UNITED STATES PATENT AND TRADEMARK OFFICE

APPLICATION NO.	FILING DATE	FIRST NAMED INVENTOR	ATTORNEY DOCKET NO.	CONFIRMATION NO.
10/526,668	03/04/2005	Emma Jane Heatley	424662010300	3153
25227	7590	06/18/2009		
MORRISON & FOERSTER LLP			EXAMINER	
1650 TYSONS BOULEVARD			MULLER, BRYAN R	
SUITE 400				
MCLEAN, VA 22102			ART UNIT	PAPER NUMBER
			3727	
			MAIL DATE	DELIVERY MODE
			06/18/2009	PAPER

Office Action Summary	Application No. 10/526,668	Applicant(s) HEATLEY, EMMA JANE
	Examiner BRYAN R. MULLER	Art Unit 3727

DETAILED ACTION

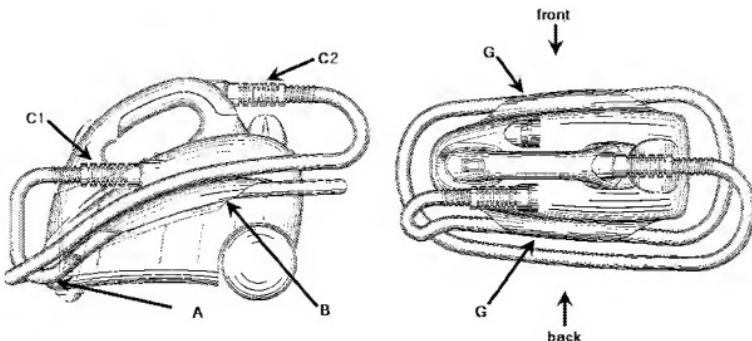
2. Claims 1, 2, 4, 6, 7, 9-12, 14, 19 and 21 are rejected under 35 U.S.C. 102(b) as being anticipated by Rosa (D452,594).
3. In reference to claim 1, Rosa discloses all of the claimed structure, wherein the terms front and back of the main body are relative terms and any of the sides may be considered to be the front ("front" defined as "the foremost part or surface of anything" or "any side or face, as of a building"¹; wherein any side may also be considered to be a foremost part, depending on the orientation of the apparatus relative to a user) with an opposing side being considered to be the back of the main body, such that the wheels are located on the sides (front and back may also be considered sides or surface between front and back with wheels thereon may be considered to be a side) and the hose storage path is closer to the base at a portion of the front and back (A) and the hose storage path increases in height from the base in the region of the wheels.

5. In reference to claim 7, Rosa further discloses first and second connectors (C1 and C2) for connecting the ends of the hose with the main body and a wand, respectively and, which are adjacent to one another.

7. In reference to claim 14, any of the guide sections (G) may be considered to be clips that are positioned along the hose storage path. A "clip" is defined as "any of various devices for gripping or holding things together"², wherein both of the guide sections either grip the hose or hold the hose against the main body, Thus reading on the limitation of a "clip".

8. In reference to claim 19, Rosa clearly shows that the hose has a length which is greater than the hose storage path and the end portions (C1 and C2) of the hose may be considered to be locators that identify portions of the hose that are to be retained in or on the main body.

9. In reference to claim 21, Rosa further discloses that the guide is located such that the hose storage path curves around at least part of the wheels (at section B).
